CITY OF HOLLY HILL, FLORIDA

1. Fountainhead MPUD Discussion of Draft Mixed Use Planned Unit Development Agreement

**STAFF REPORT
CITY OF HOLLY HILL, FLORIDA**

DATE: November 16, 2016
SUBJECT: Fountainhead MPUD
APPLICANT: Michael Woods, Cobb Cole
NUMBER: Z-2015-05
PLANNER: Thomas Harowski, AICP

Exhibit B
Mixed Use Master Development Plan

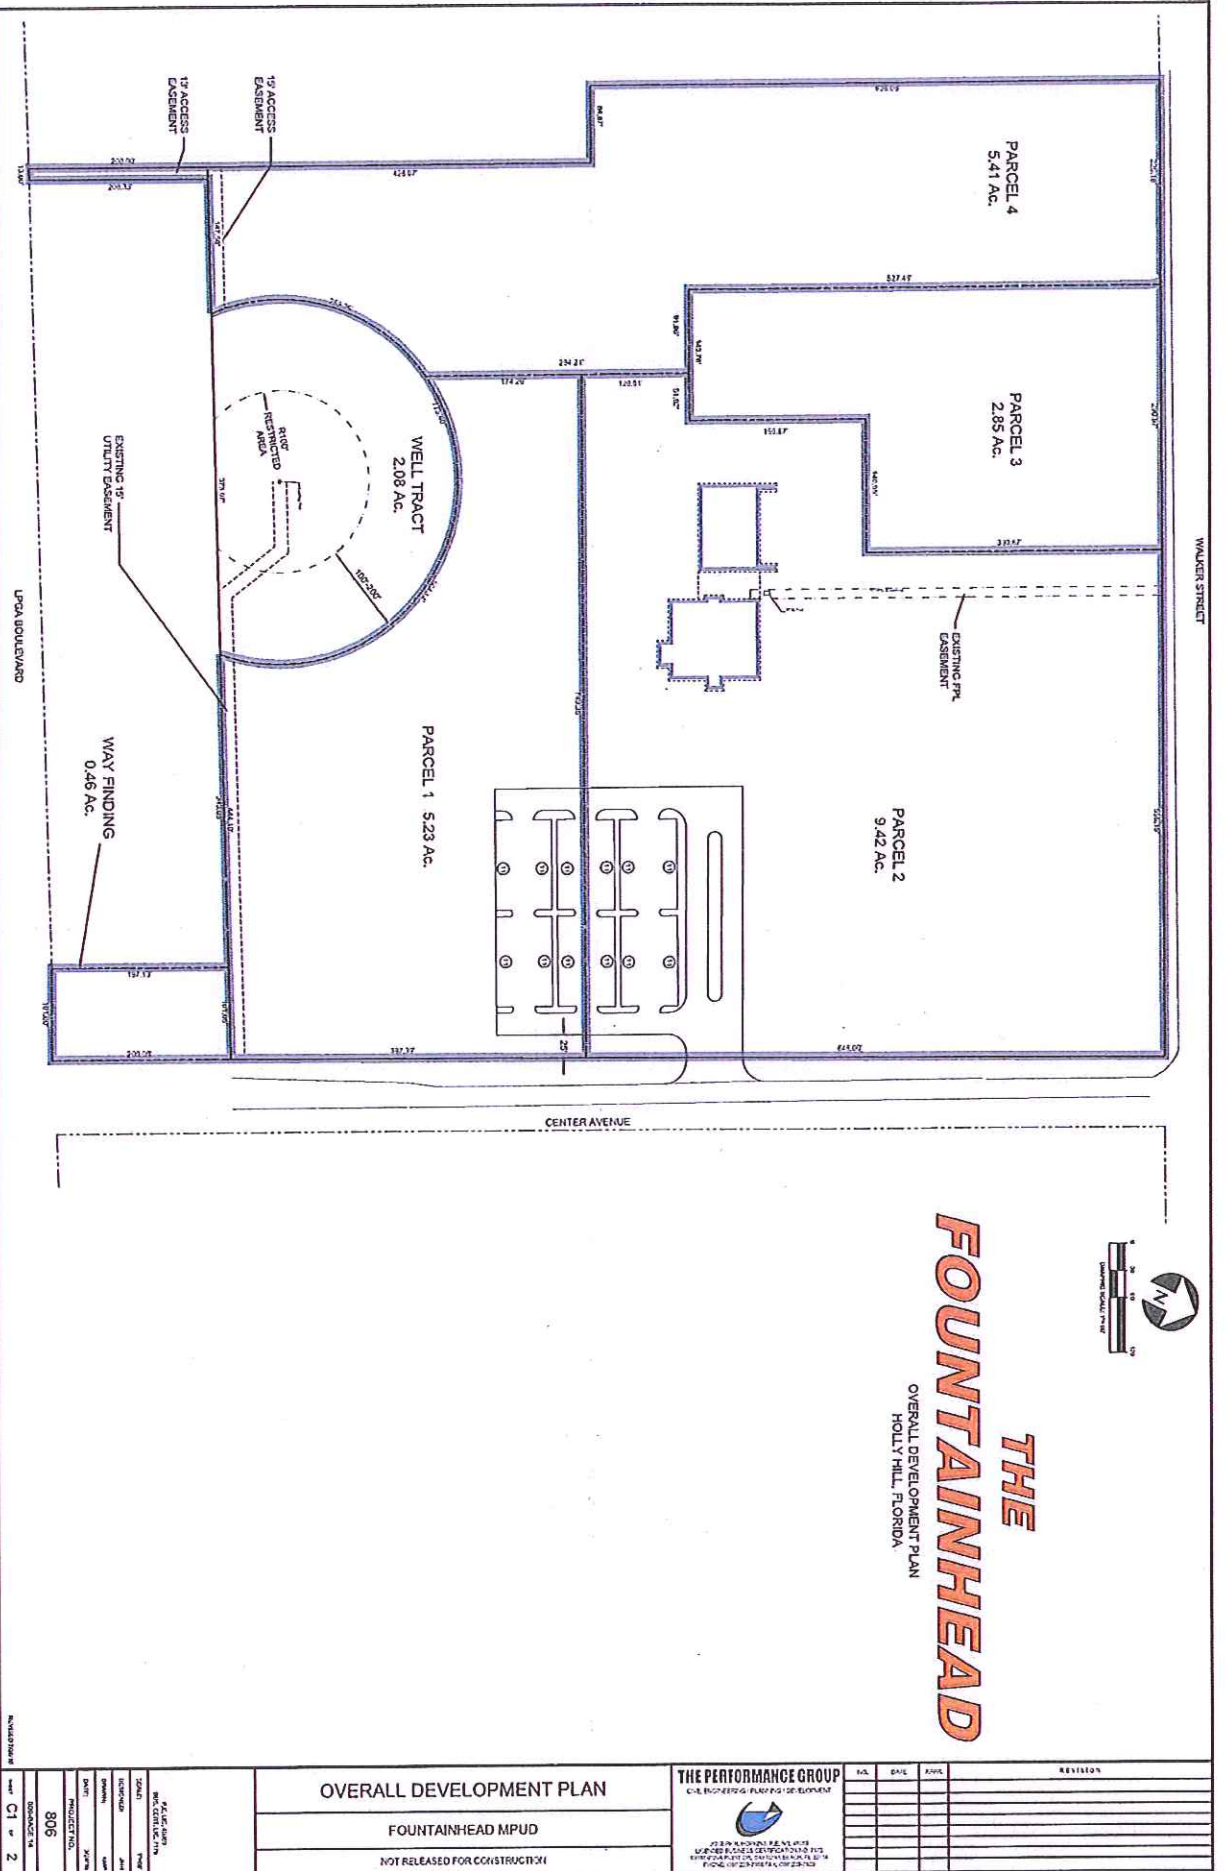
- The parking lot landscaping does not meet City code minimums. Code requires a landscape island after 10 parking spaces. The master development plan shows parking runs that exceed this limit.

- c. The southern property buffer needs to be added to the north of the City easement. As the current plan is drawn, the easement is shown and no buffer is identified. The City cannot accept the buffer in the easement area.

20. As a note on the site plan, is there a reason the proposed patio located to the south of the accessory use building has been placed away from the potential users?

21. As we have noted before in the site plan layout, the day care facility will benefit from a drop-off area that is separate from the parking lot drive lanes. This design is a recipe for congestion during drop-off and pick-up times.

Commented [TH22]: Graphic shows 11 spaces between planter islands, while city code is no more than 10 spaces. There is some specific need keyed to the site design that is a deviation from the code.

EXHIBIT KEY

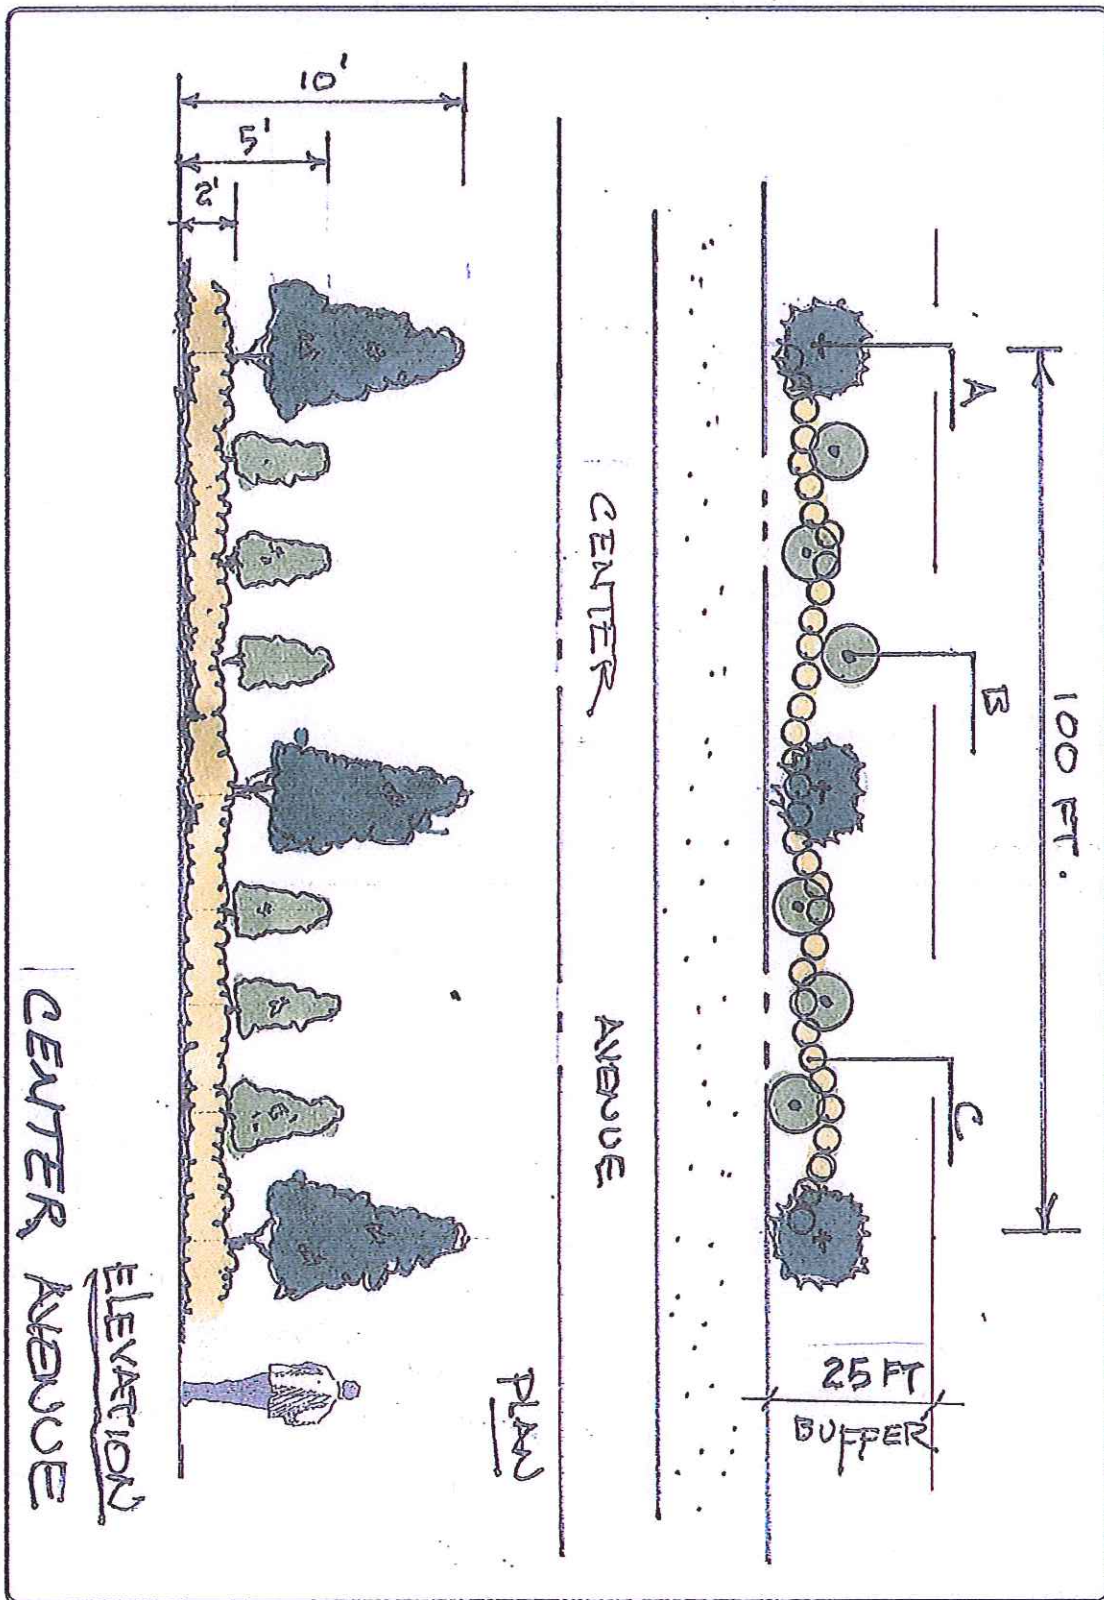
- The Center Avenue buffer is essentially a line of trees and a hedge. This layout is essentially code minimum and does not meet the City's desired landscape outcome. The agreement text varies the Center Avenue buffer from 20 to 25 feet while the design specifies 25-feet. The 25-foot wide buffer is the design dimension that had been in the program until the current draft was submitted. Having added depth along Center Avenue is important to allowing improved design and to the placement of trees along the western edge of the buffer where conflicts with overhead utilities will be minimized.

Commented [TH18]: This means the minimum buffer when drawing shows 25-feet. A larger buffer should be provided along Center Avenue and Walker Street as the frontages are where the highest impacts to adjacent property will be incurred. The wider buffer will allow trees to be closer to the interior side of the buffer and thus avoid or minimize impacts from overhead power lines.

5.

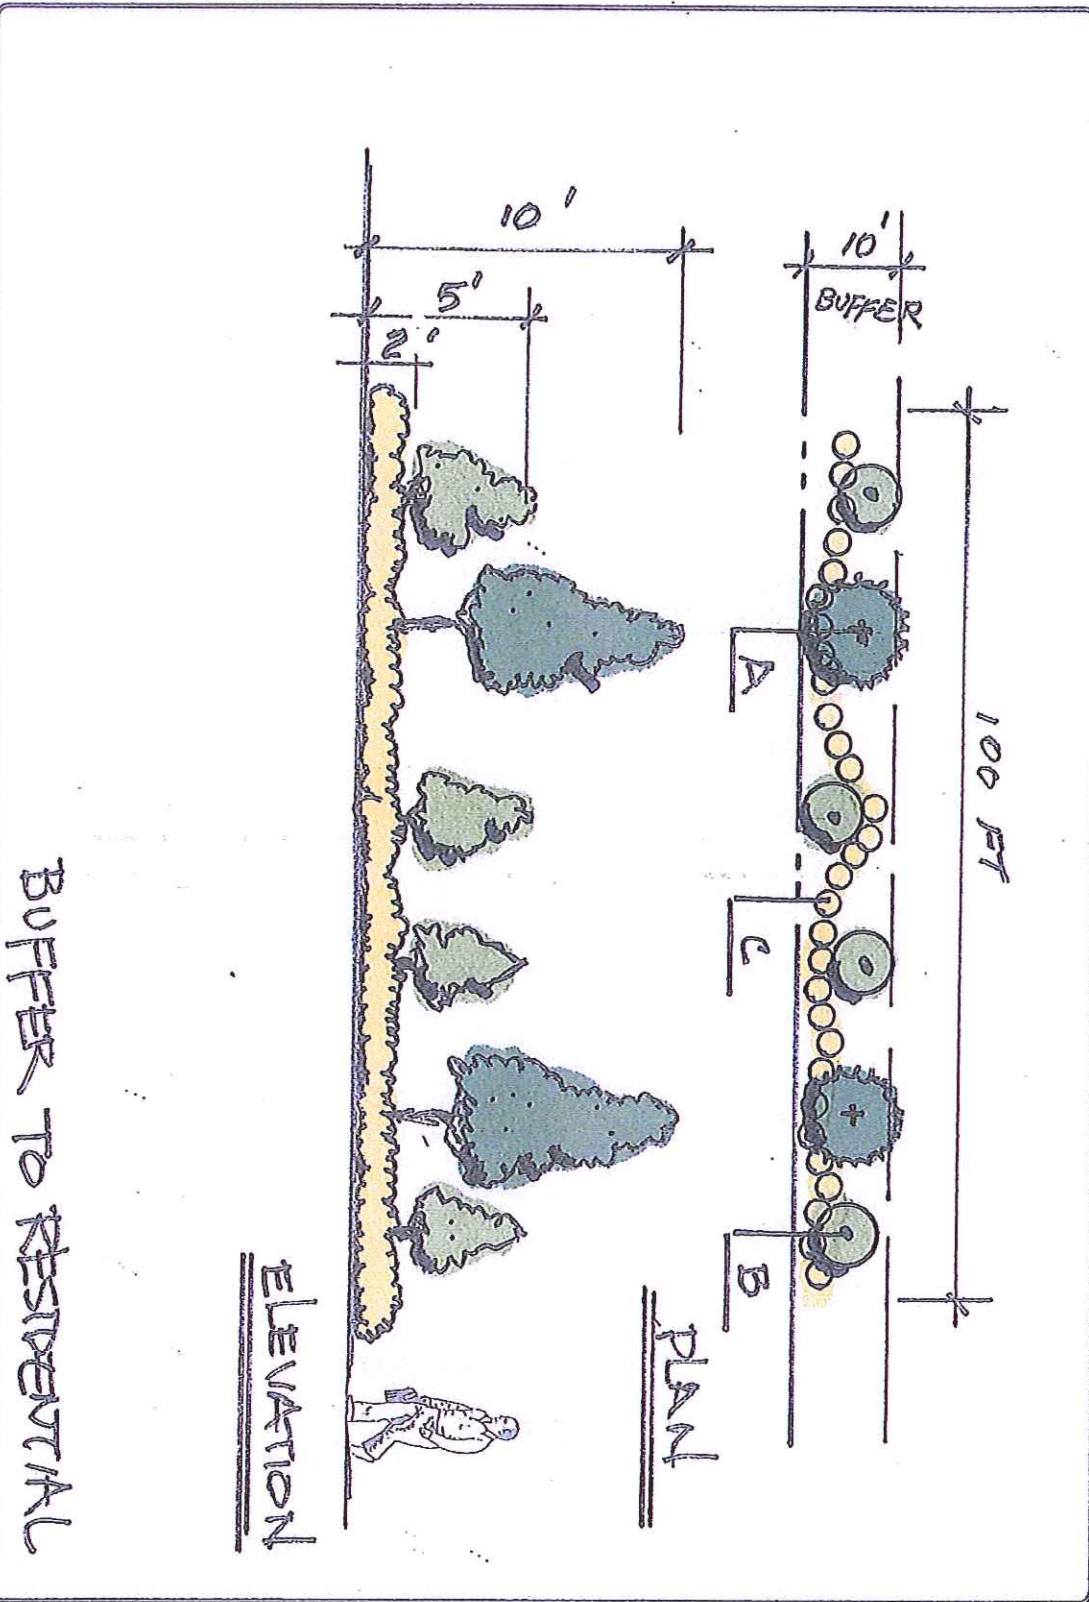
- Section 11 discusses the proposed buffers for Parcel 4 (Tract 4) which is the residential tract. The applicant's proposal is to construct the 10-foot residential buffer along the western boundary of the project. The buffer again is a minimal buffer under the city code. The abutting uses along the residential parcel are the head start center and a wooded area, so the project impacts are not directly affecting residential use. The discussion of the Parcel 4 buffers also states that the applicant may extend the residential buffer along the northern portion of the Tract (Walker Street). Staff believes the project buffer along Walker Street should be consistent throughout the length of the project.
